Access Compliance Report

Public Rights-of-Way

(Curb Ramps)

Intersection ID: 7486	Main Street: TRYON_ST	Cross Street: OWEN_ST	Location: NE
ADA ID: 971101BB7982	Ramp Type: Directional1	Initial Pass/Fail: Pass	Overall Compliance: No
Codes/Mitigation Info/Possible Solution			Severity Score: 0
			Field Measurements/Component Compliance

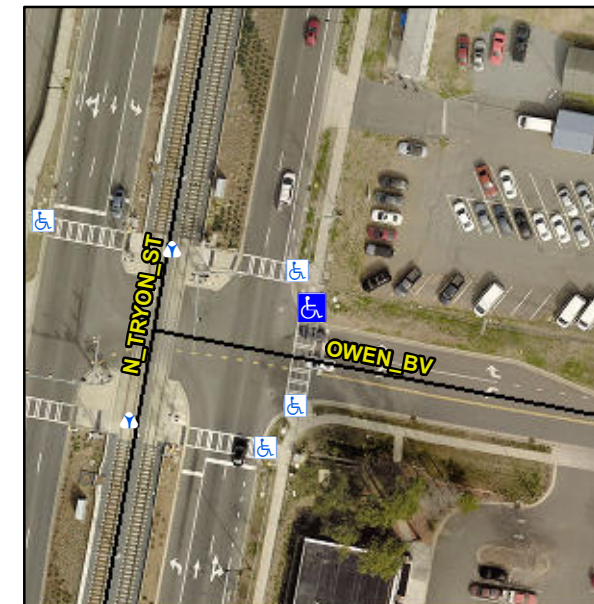
Possible Solutions:

Remove & Replace Detectable Warning System.

PROW/ADA:

R305.2
